**TOWN OF NEWBURGH
PLANNING BOARD
TECHNICAL REVIEW COMMENTS**

PROJECT NAME: NEWBURGH SELF STORAGE-1420 ROUTE 300
PROJECT NO.: 24-6
PROJECT LOCATION: SECTION 60, BLOCK 3, LOT 22.222/1420 Route 300
REVIEW DATE: 26 JULY 2024
MEETING DATE: 1 AUGUST 2024
PROJECT REPRESENTATIVE: COLLIERS ENGINEERING/JUSTIN DATES, RLA

Newburgh Self-Storage - 1420 Route 300

Below please find our responses to comments received from MHE Engineering dated June 14, 2024. The comments have been repeated here for clarity:

BUILDING ELEVATIONS

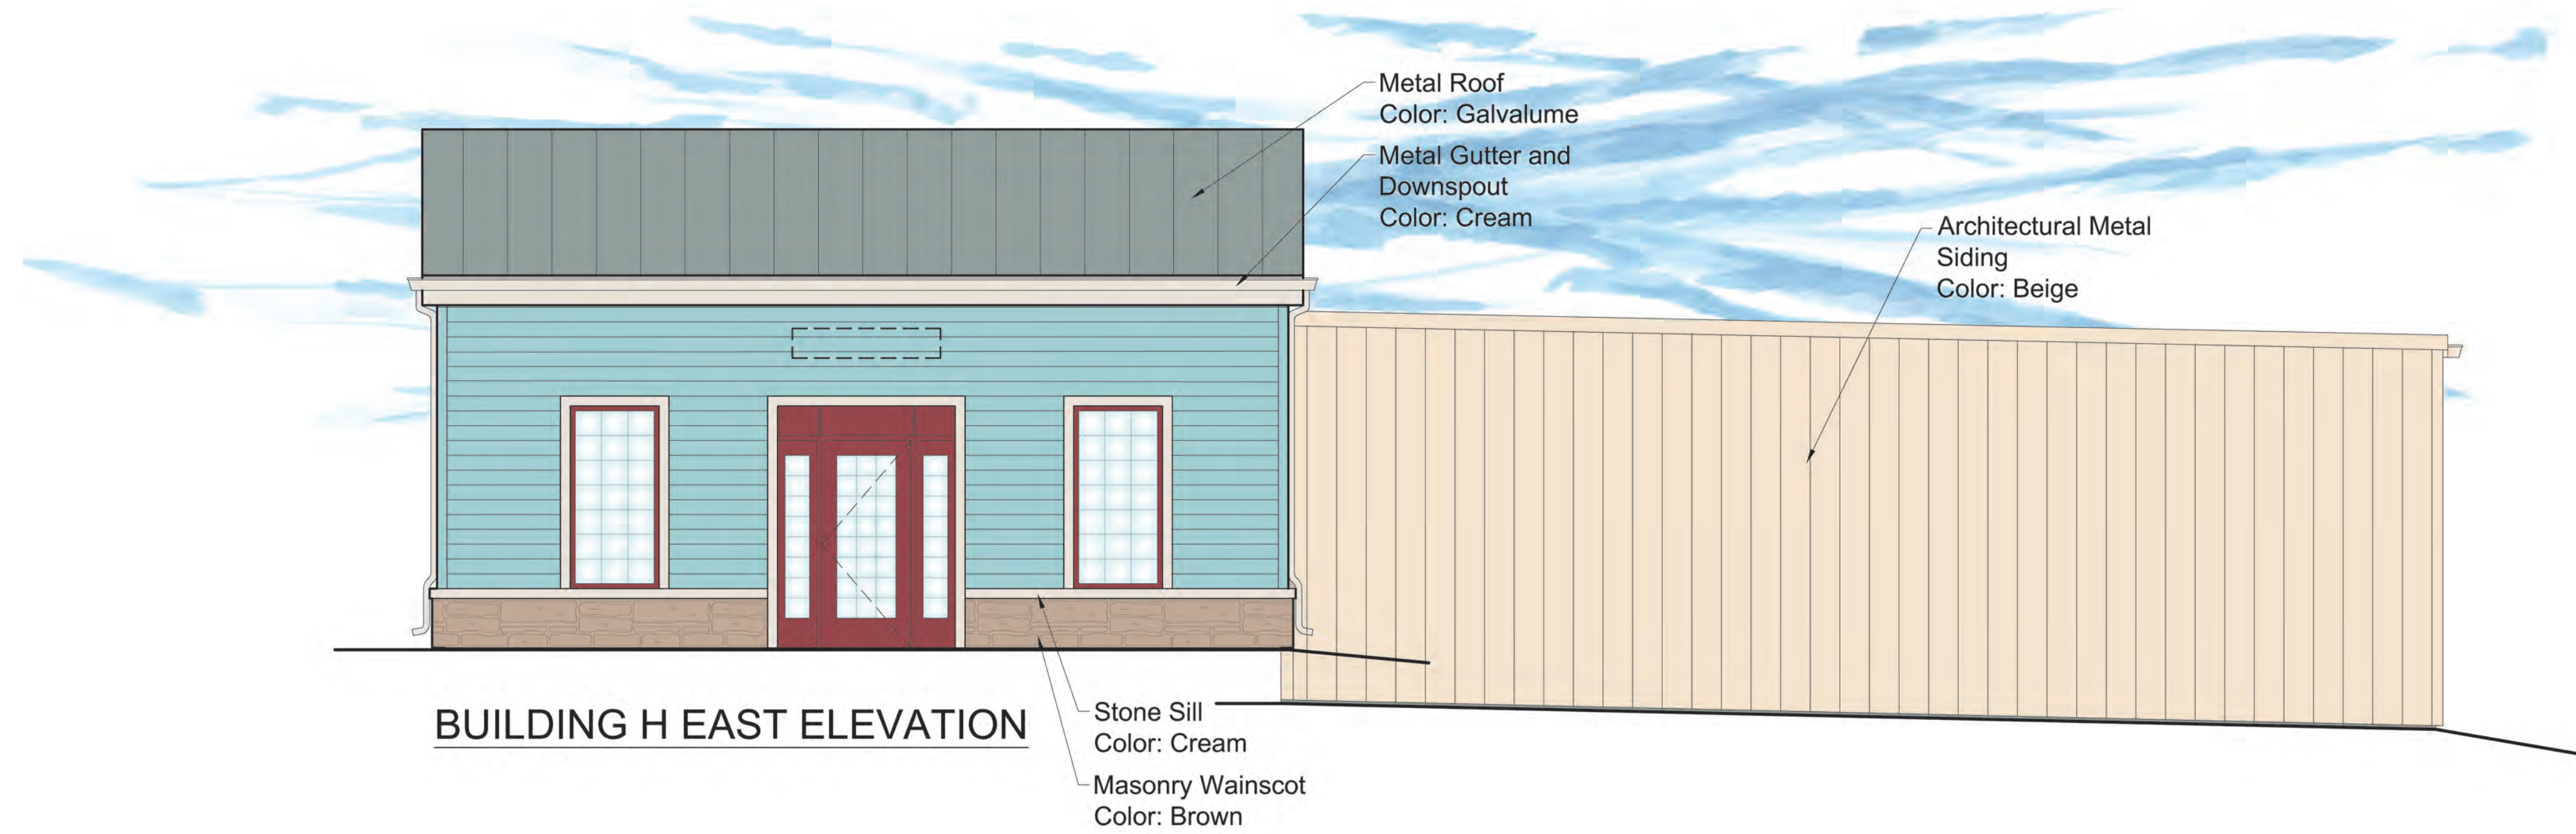
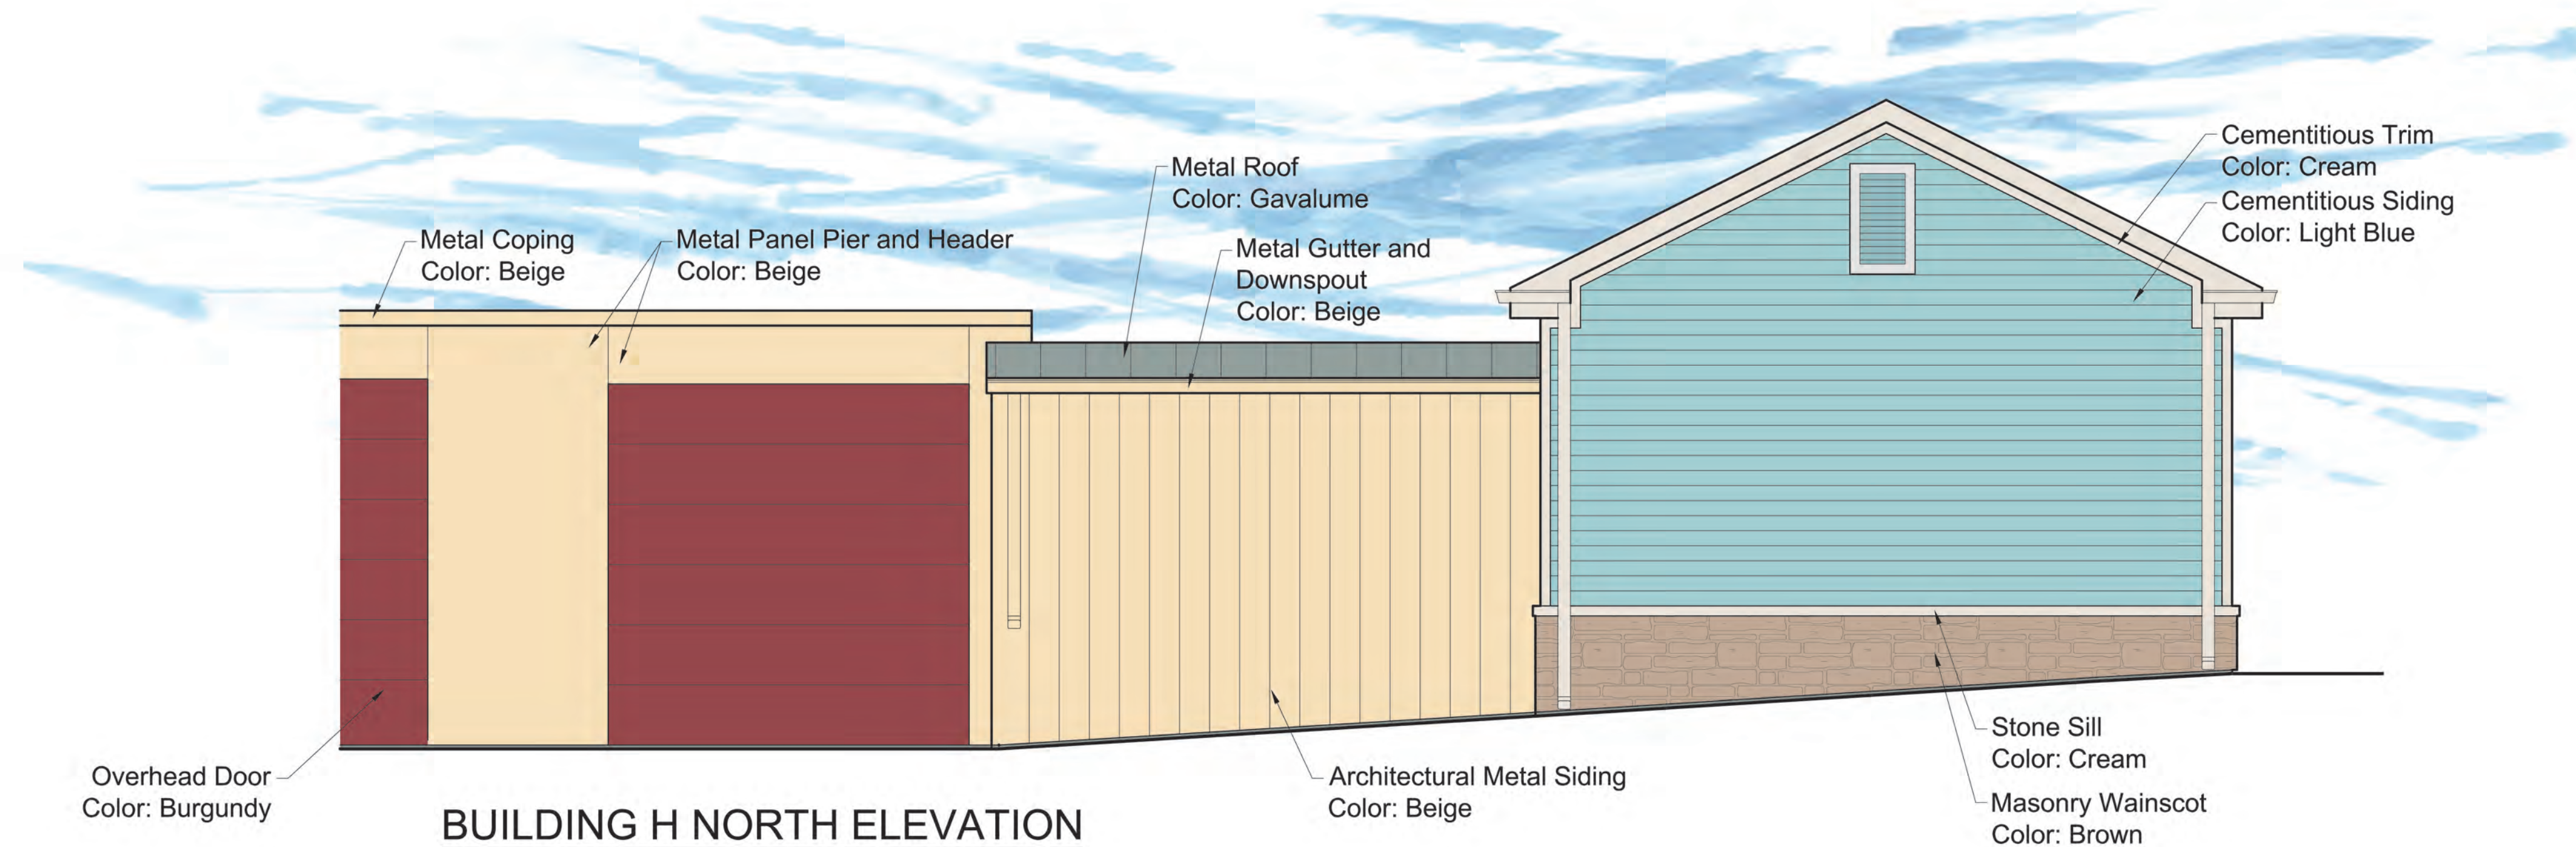
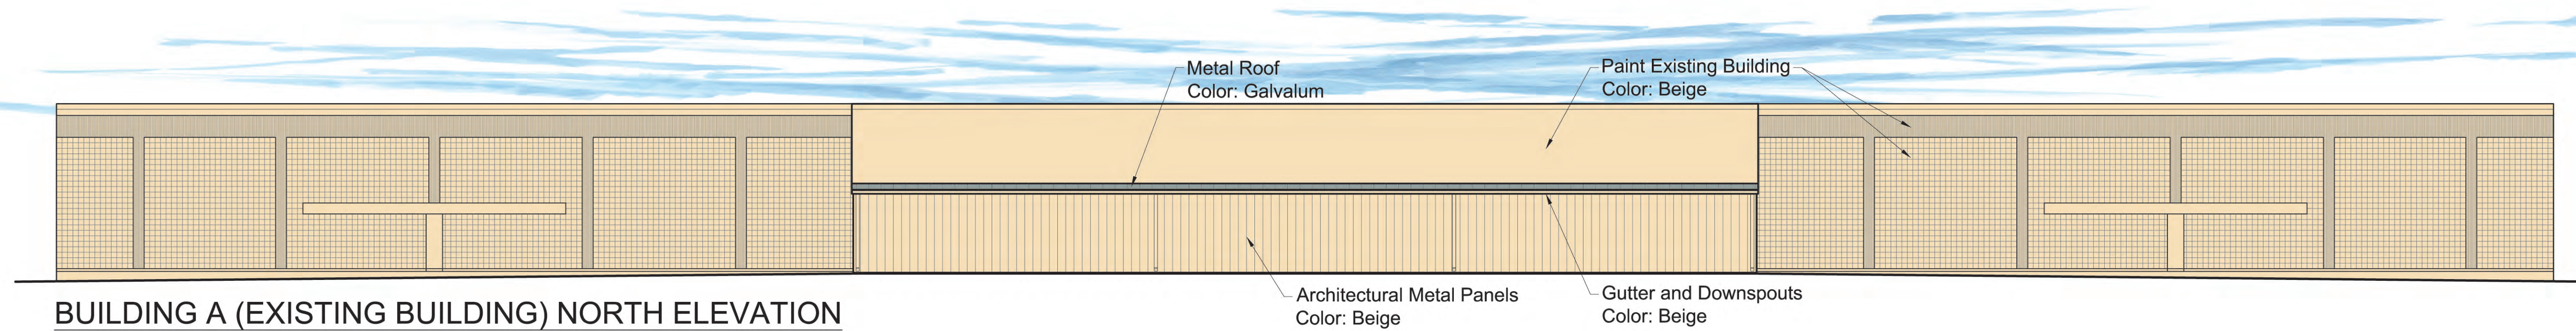
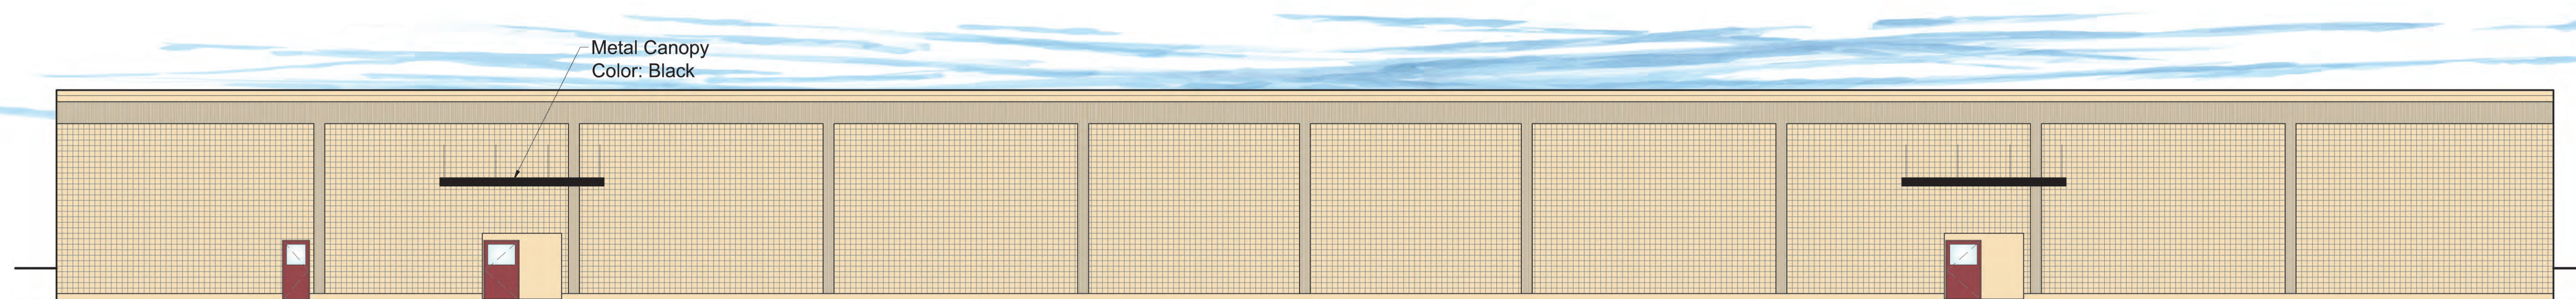
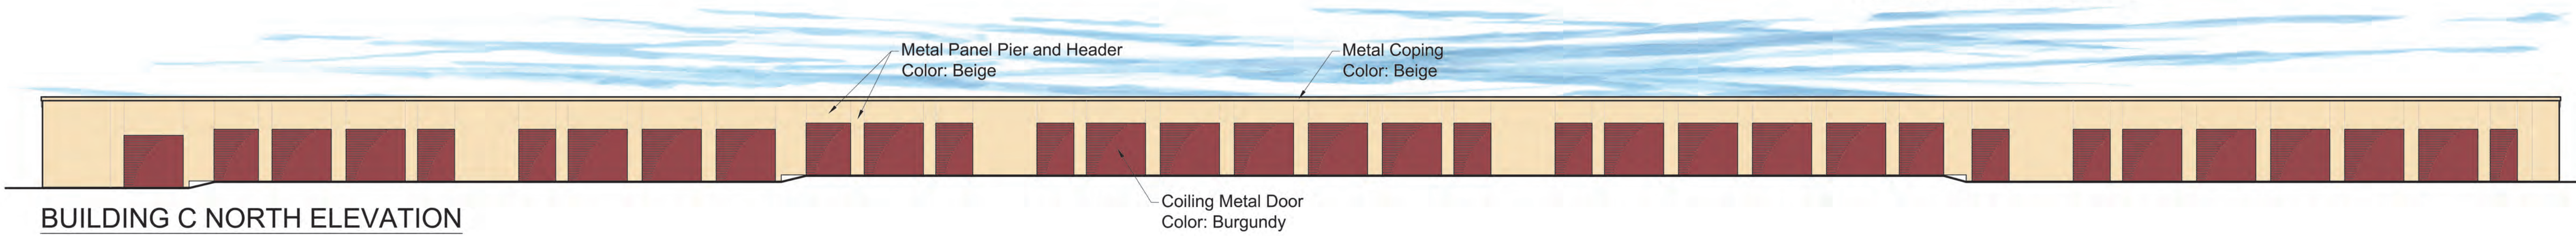
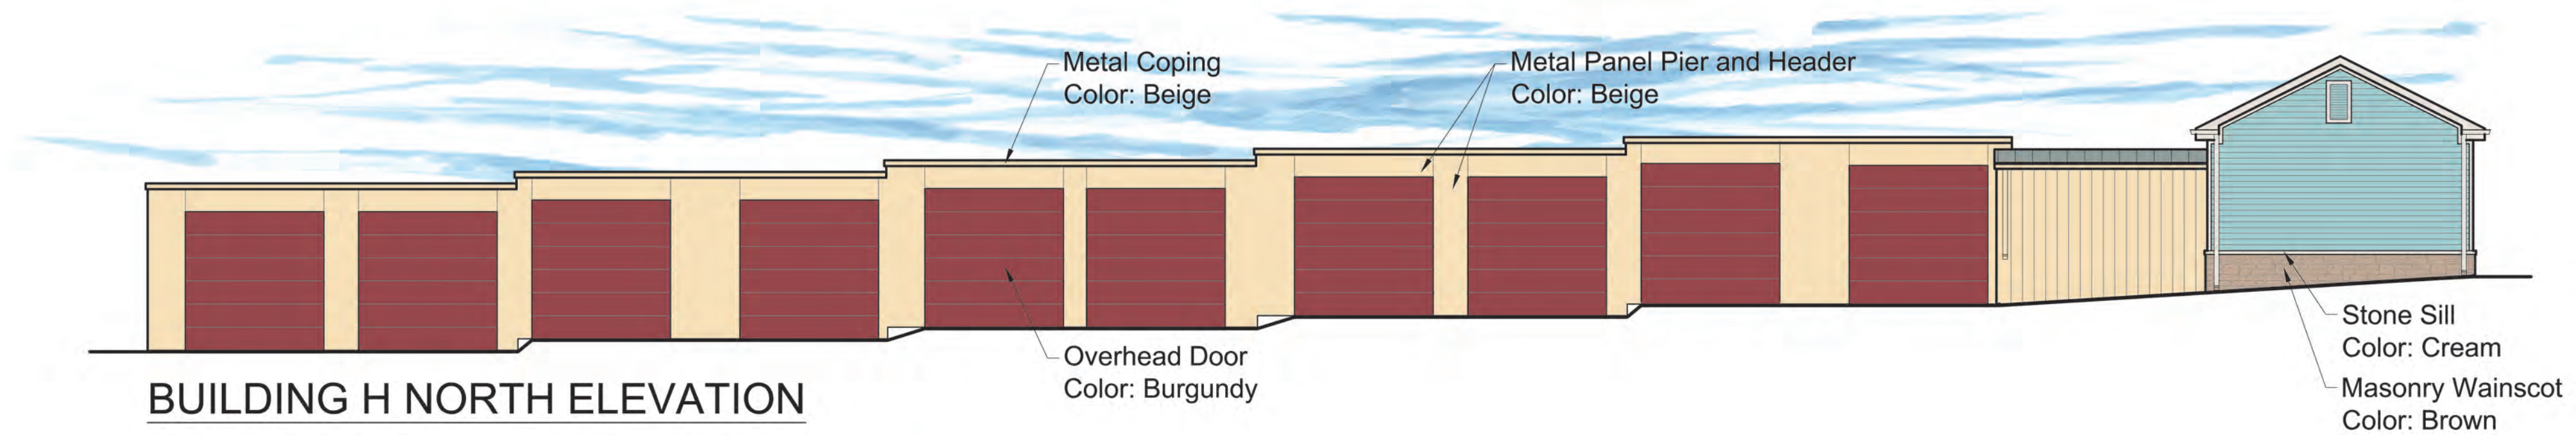
Comment 7: The project is subject to architectural review by the Planning Board. Future architectural submissions are identified as to provided.

Response 7: Attached with this submission, please find rendered, Architectural Elevations for the project & an updated Architectural Review Form. The applicant will present these items to the Board at the next meeting.
